Model: PR-C1(1-Bin Tray BN3020)	Date: 1-Apr-09	No.: RD010020a
---------------------------------	----------------	----------------

RTB Reissue

Subject: Guide: Tray: 1-Bin		Prepared by: M. Ishihara	
From: 1st Tech. Support Sec. Service Support Dept.			
Classification:	<input type="checkbox"/> Troubleshooting <input type="checkbox"/> Mechanical <input type="checkbox"/> Paper path <input type="checkbox"/> Product Safety	<input checked="" type="checkbox"/> Part information <input type="checkbox"/> Electrical <input type="checkbox"/> Transmit/receive <input type="checkbox"/> Other ()	<input type="checkbox"/> Action required <input type="checkbox"/> Service manual revision <input type="checkbox"/> Retrofit information <input type="checkbox"/> Tier 2

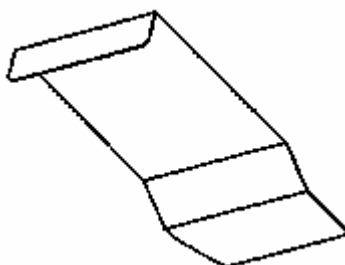
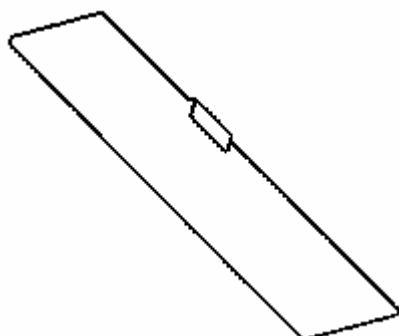
- 1) Two guides (D3394451) were added to the exit tray.
- 2) A guide (D3394452) was added to the lower frame.

Reason: To further minimize exit jams caused by paper curl.

The material of those guides is transparent Mylar.

Note: *This modification has been applied to the October 2007 production machines onward. (Machine serial No. M40782xxxxx -)*

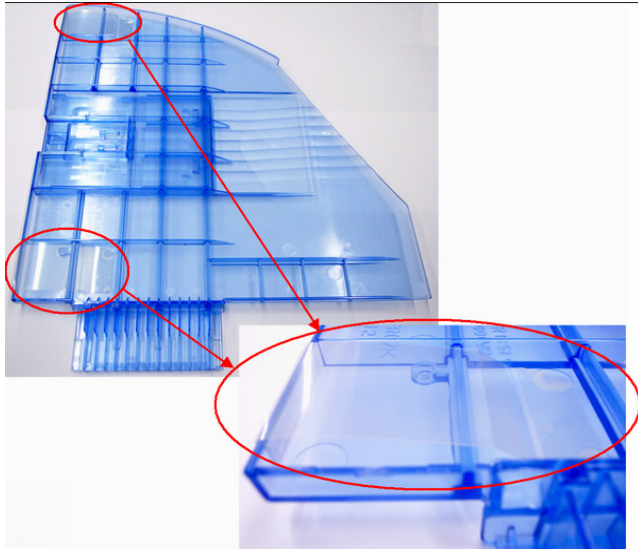
P/N D3394451

Note: *The two guides are attached to the underside of the exit tray using double-sided tape.*

**P/N D3394452**

Note: *This guide is attached to the underside of the lower frame using double-sided tape.*
